MIL-PRF-19500/673
AMENDMENT 1
20 August 2001

PERFORMANCE SPECIFICATION

SEMICONDUCTOR DEVICE, FIELD EFFECT RADIATION HARDENED
(TOTAL DOSE AND SINGLE EVENT EFFECTS)
TRANSISTOR, N-CHANNEL, SILICON TYPES 2N7468U2 AND 2N7469U2
JANTXVR, F, G, AND H, AND JANSR, F, G, AND H

This amendment forms a part of MIL-PRF-19500/673, dated 9 March 2001 and is approved for use by all Departments and Agencies of the Department of Defense.

FIGURE 2. Thermal response curve. "

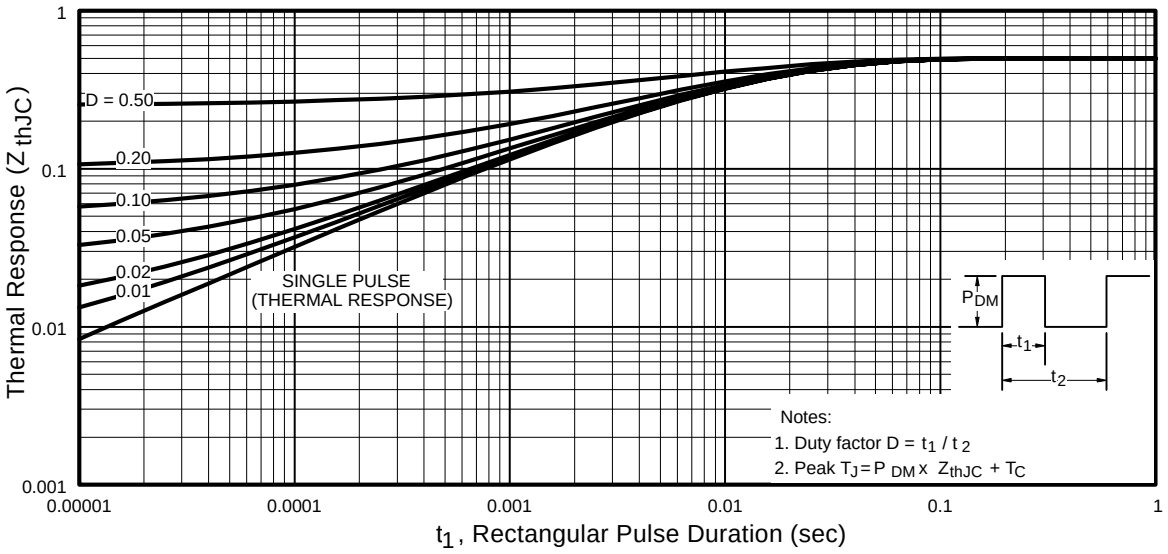
FIGURE 2, delete and substitute:
“

FIGURE 3. Safe operating area graph. "

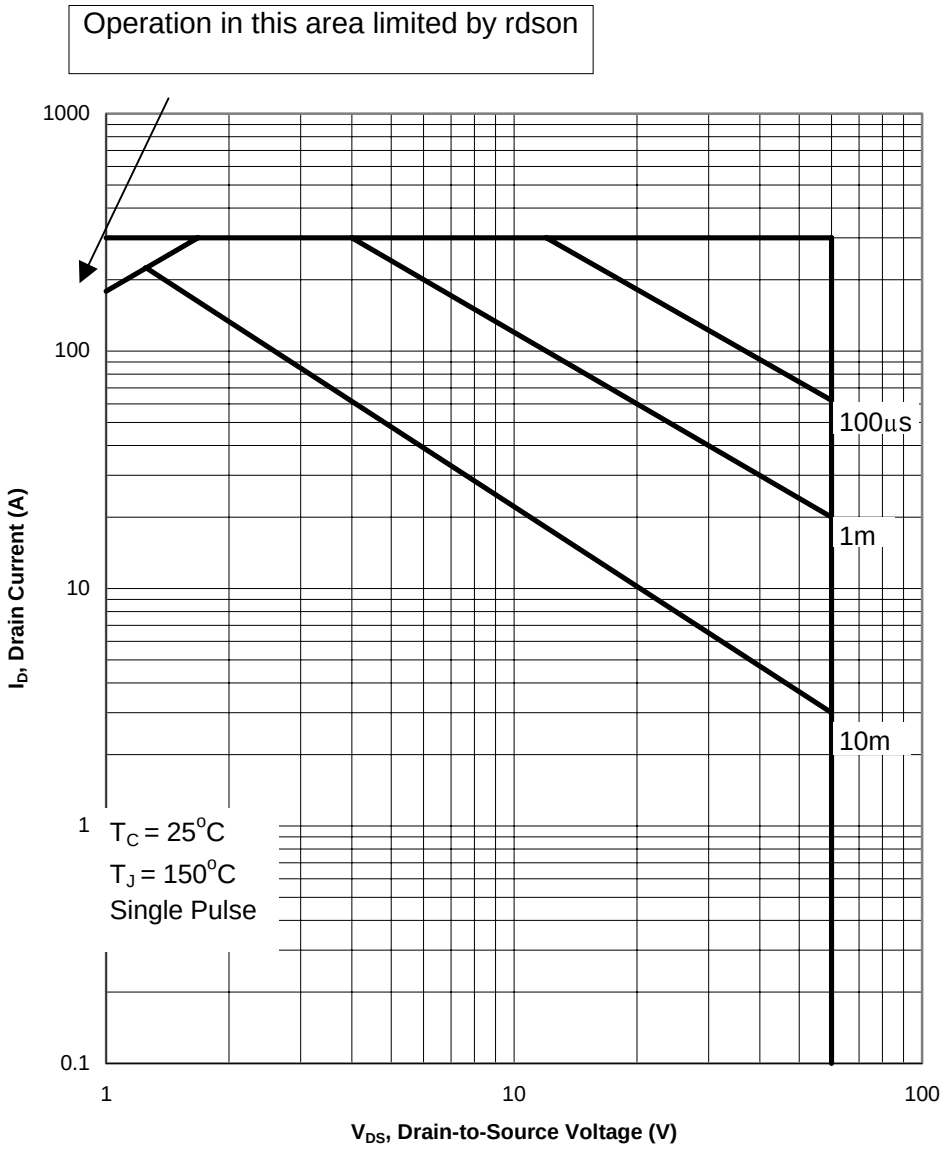
FIGURE 3, delete and substitute:
“

FIGURE 4. Safe operating area graph. "

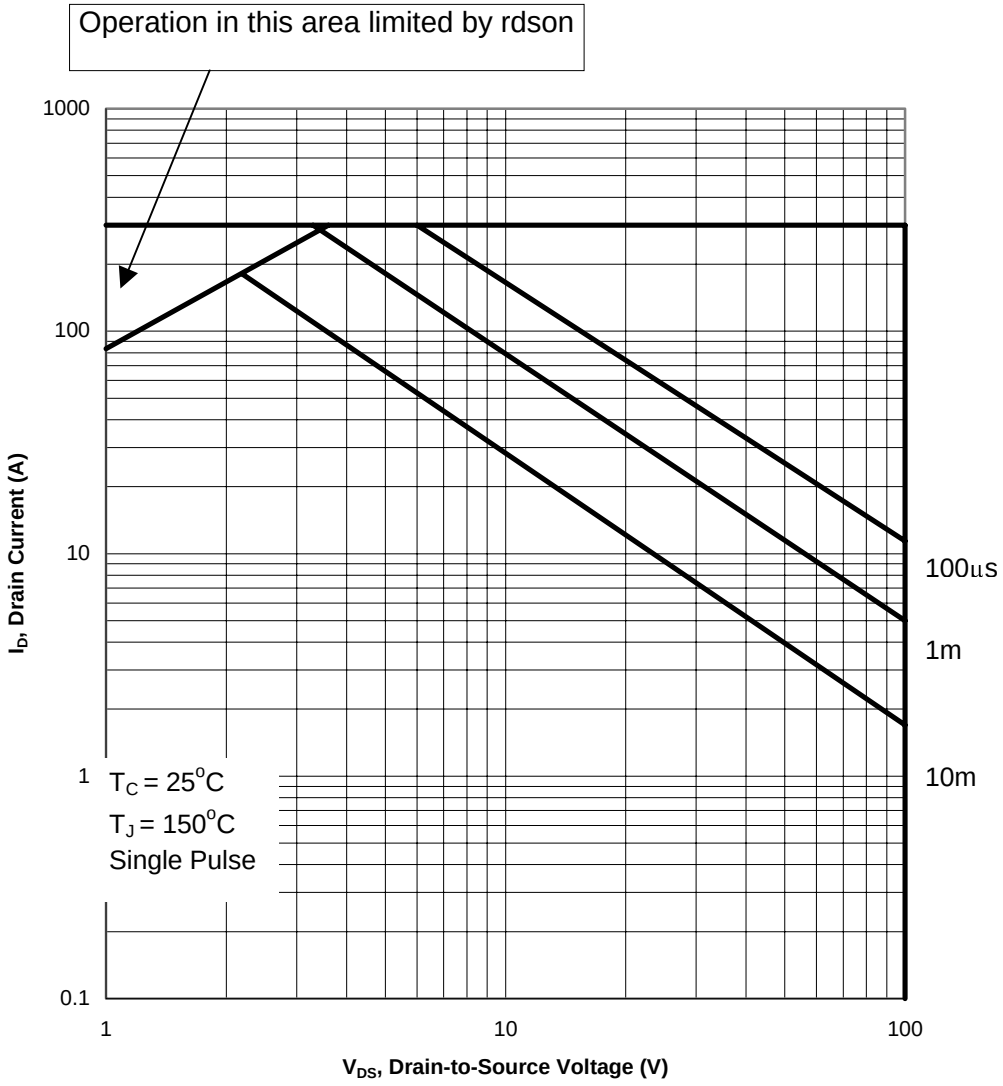
FIGURE 4, delete and substitute:
“

FIGURE 5. SEE safe operating area graph. "

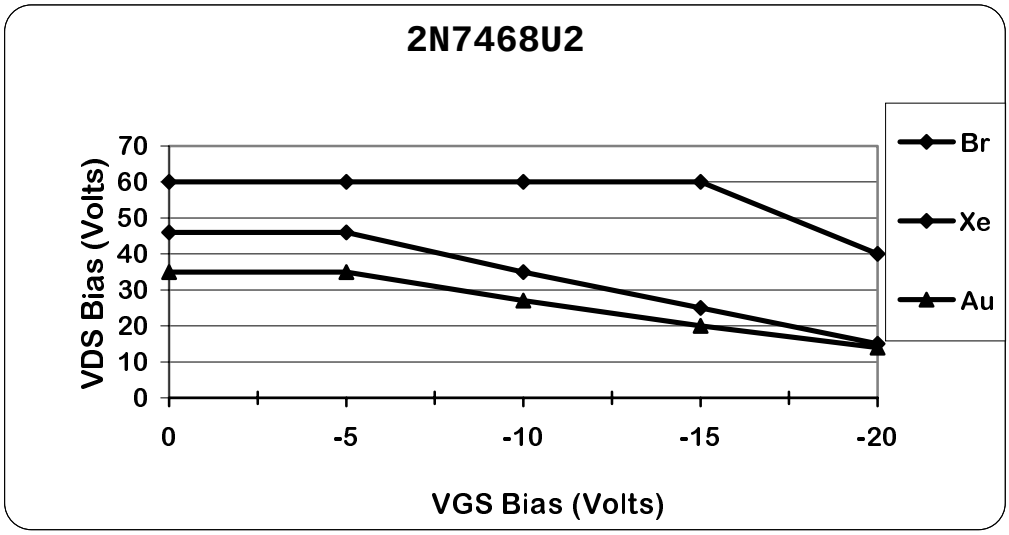
FIGURE 5, delete and substitute:
“
